ARCHITECTURAL REVIEW BOARD MEETING
CITY HALL, 385 SOUTH GOLIAD, ROCKWALL, TEXAS
OCTOBER 11, 2022 IN THE CITY COUNCIL CONFERENCE ROOM AT 5:00 PM

(1) **SP2022-050 (HENRY LEE)**

TO: Planning and Zoning Commission
DATE: October 11, 2022
APPLICANT: Jeff Carroll; *Jeff Carroll Architects*
CASE NUMBER: SP2022-050; *Amended Site Plan for Bacon Plumbing*

Re: SP2022-050 Variance Requested
Bacon Properties Development Phase 2
Rockwall, TX.

1 ARCHITECTURAL SITE PLAN
SCALE: 1" = 30'-0"

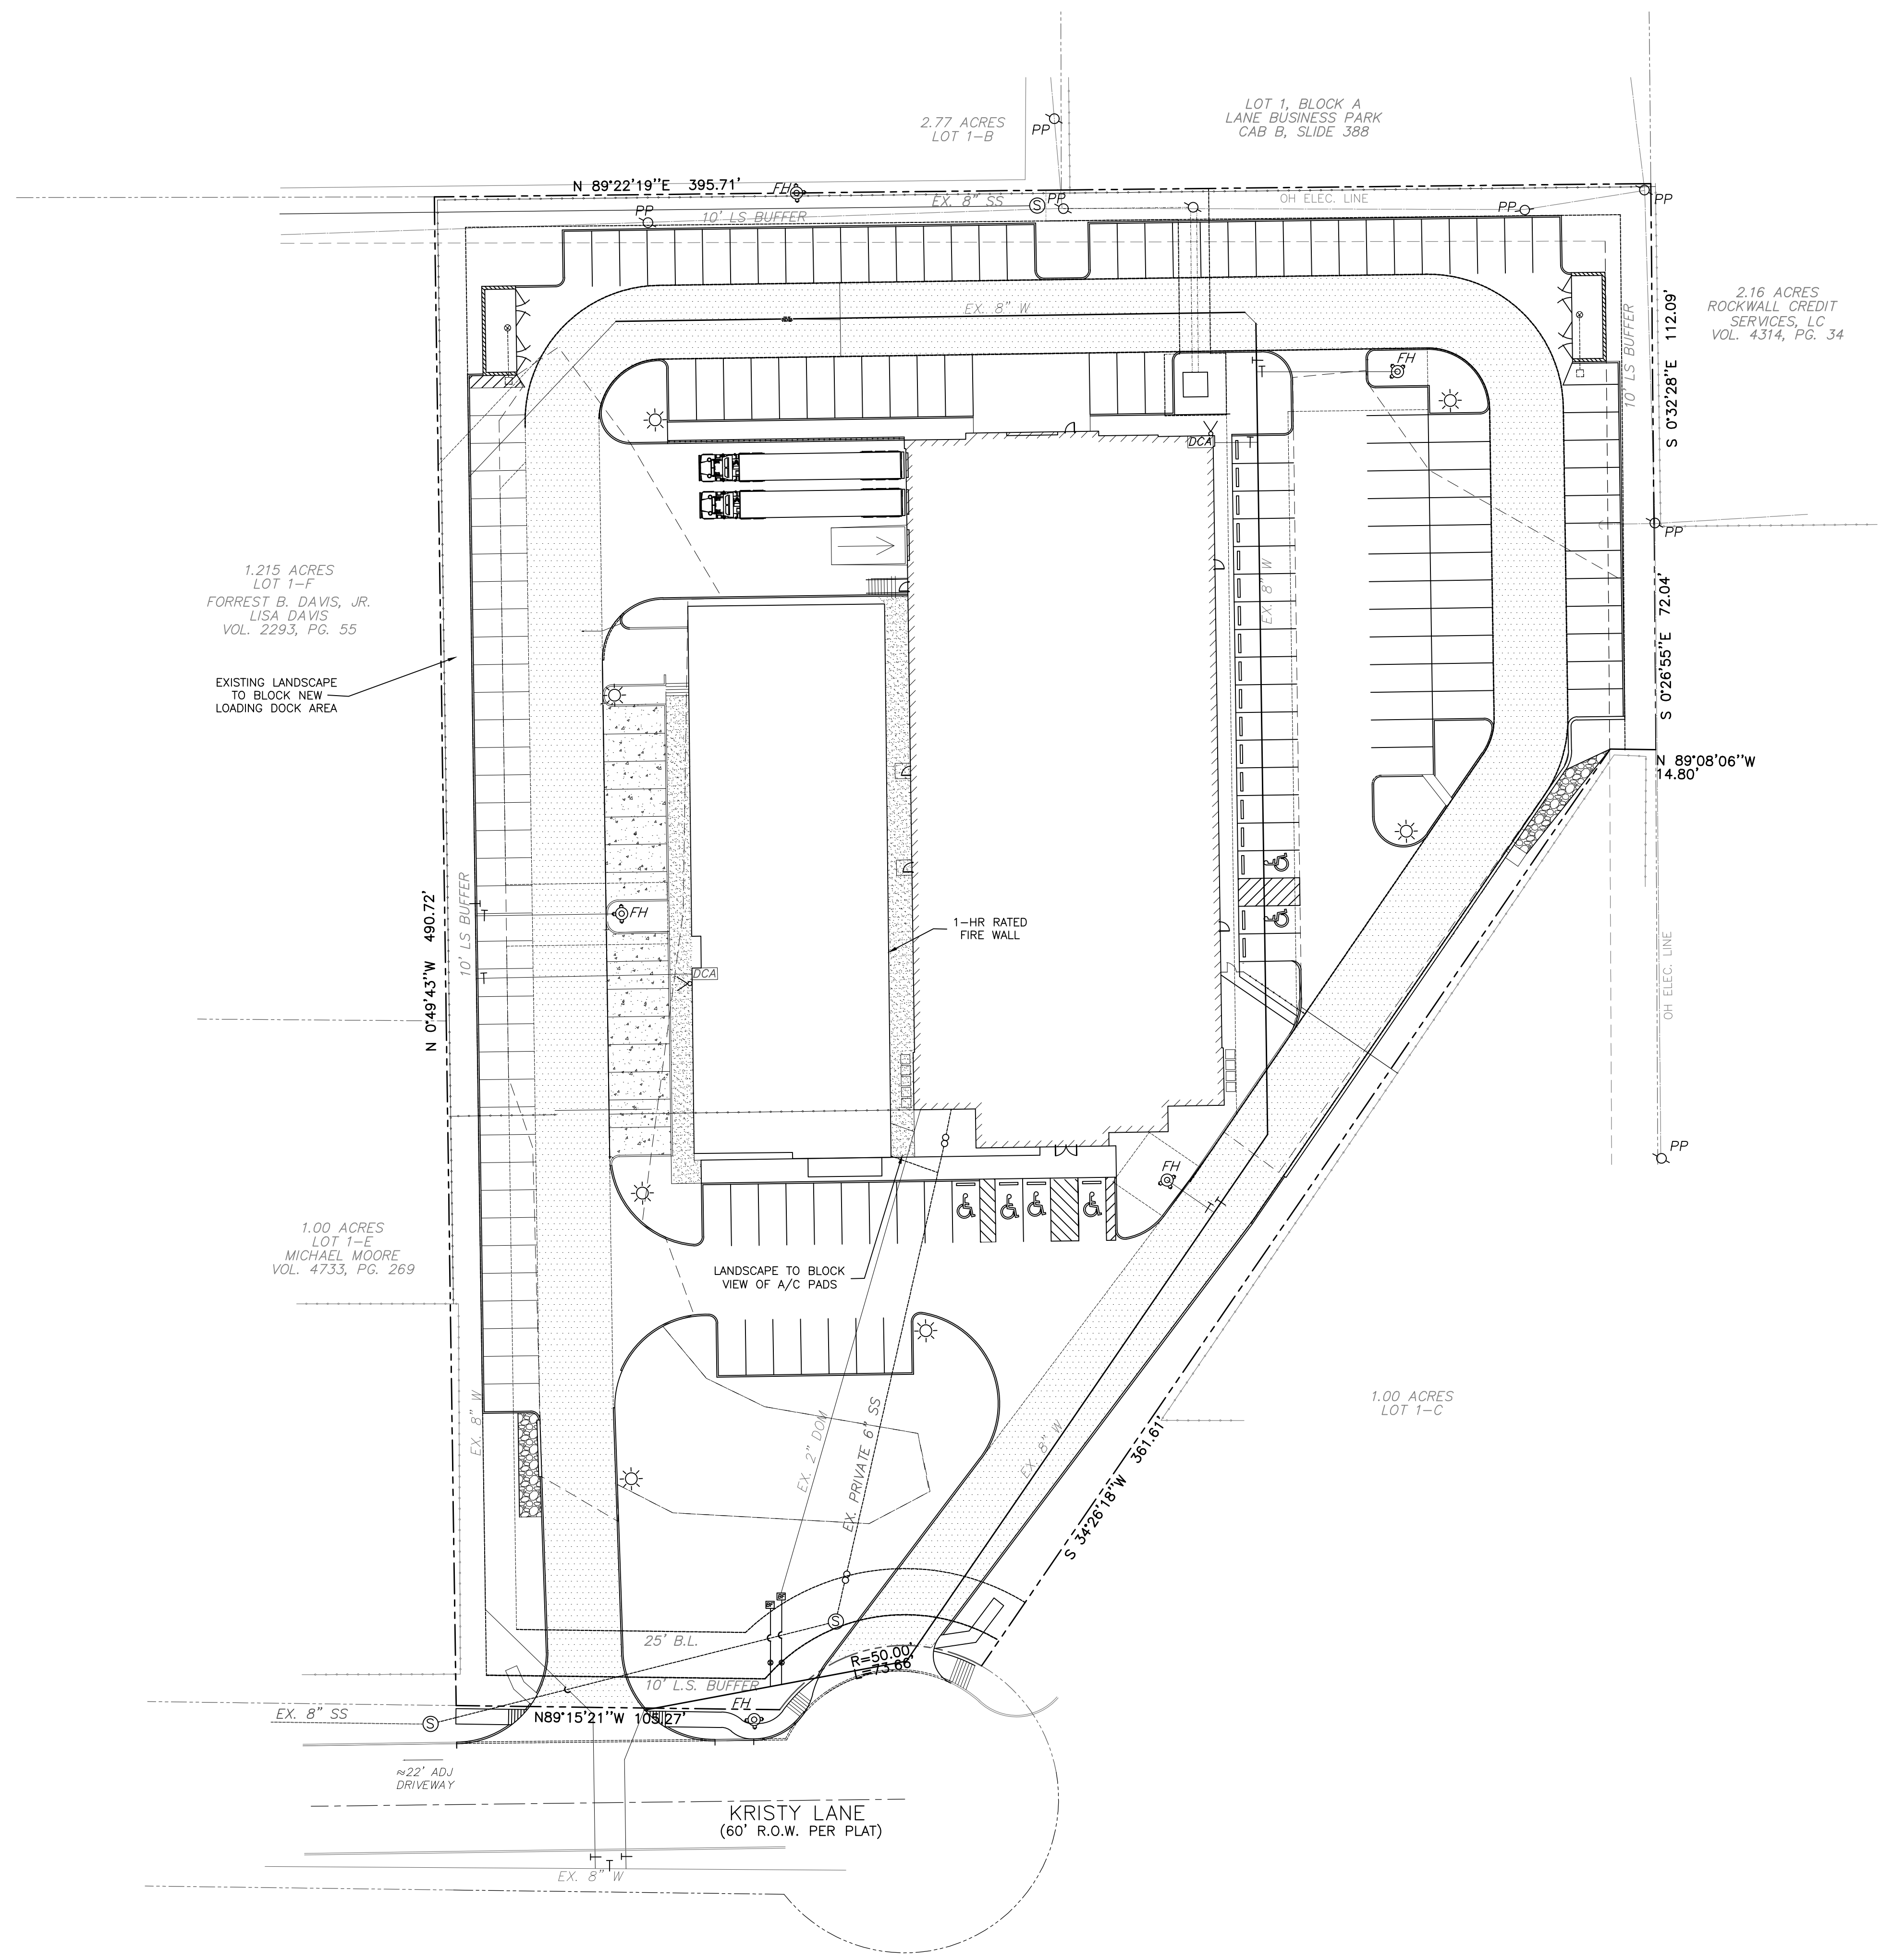
Subsection 5.02, *Light Industrial (LI) District*, of Article 05, *District Development Standards*, of the Unified Development Code (UDC), states that the “Light Industrial (LI) District is a zoning district intended to create a limited industrial zone that provides for modern types of industrial land uses.” The proposed office/warehouse facility is a permitted land use in the Light Industrial (LI) District. Additionally, the code goes on to say that all operations shall be indoors with no outside storage of materials unless properly screened or buffered. The code also states that “...locations for these types of industrial land uses are typically a minimum of two (2) acres and average of five (5) to ten (10) acres.” In this case, the subject property generally meets these guidelines and is 3.57-acres. It should be noted that staff made the comment to the applicant to continue the landscaping screening down the west property line to properly screen the proposed off-street loading. The applicant has chosen not to address this comment.

- (1) All staff comments provided by the Planning, Engineering and Fire Department must be addressed prior to the submittal of engineering plans.
- (2) Landscape screening shall be installed along a portion of the west property line to the screen the proposed off-street loading.
- (3) All utility equipment will be screened per Subsection 01.05 (C), *Utility Equipment and Air Conditioning Units*, of Article 05, *District Development Standards*, of the Unified Development Code.
- (4) Any construction resulting from the approval of this Site Plan shall conform to the requirements set forth by the Unified Development Code (UDC), the International Building Code (IBC), the Rockwall Municipal Code of Ordinances, city adopted engineering and fire codes and with all other applicable regulatory requirements administered and/or enforced by the state and federal government.

EXISTING LANDSCAPE
TO BLOCK NEW
LOADING DOCK AREA
